RE: Skyline View Ranch

I have reviewed the application to have the parcel RP04N44E120150 divided into a seven (7) lot subdivision to be known as the Skyline View Ranch and determined that the property is suitable for sub-surface waste disposal systems to serve residences. Four test holes were excavated on May 24, 2023, to provide observation of the soil horizon below natural grade.

I. NAME OF SUBDIVISION: Skyline View Ranch.

TEST HOLE INFORMATION

Test Hole # 2

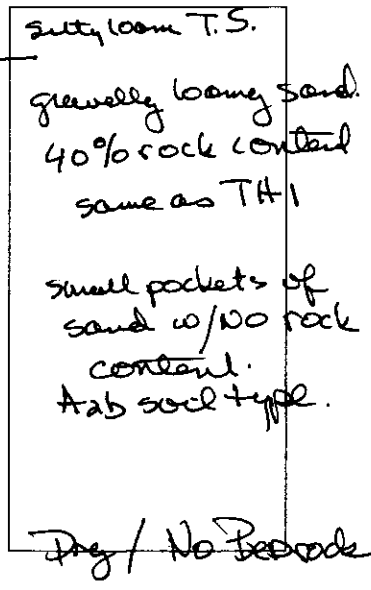
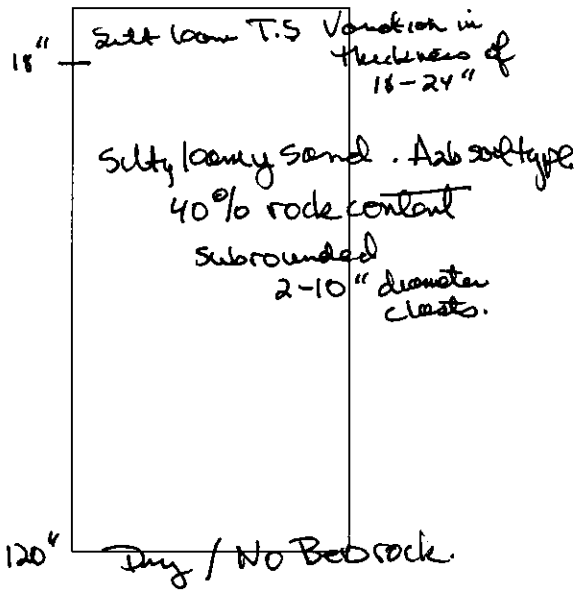
Notes increasing
Rock content
w/ Depth.

All soils are
basically the same
through out parcel.

East portion of
Parent parcel

Test Hole # 3

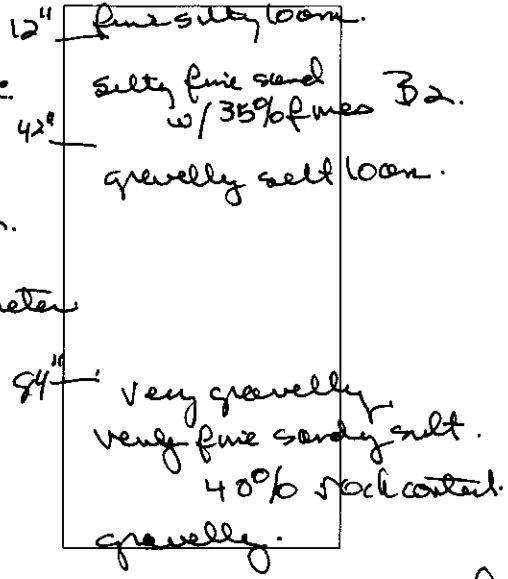
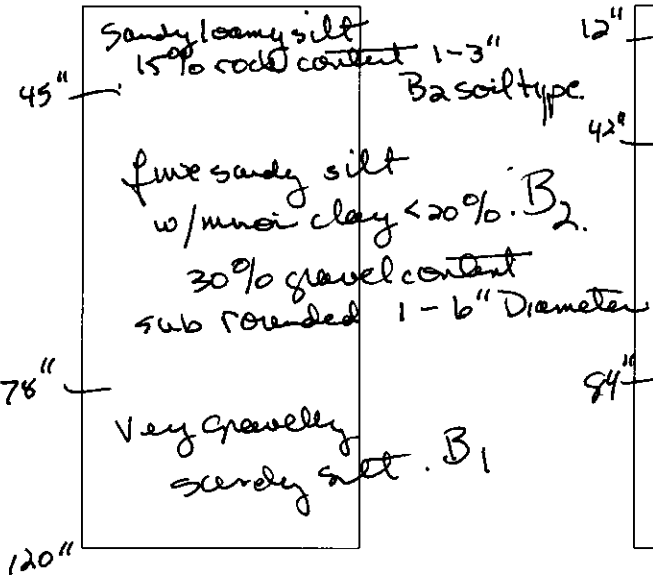
Size all
systems w/
B2 application
rate
0.45 gpd/ft

West side of Parent parcel.
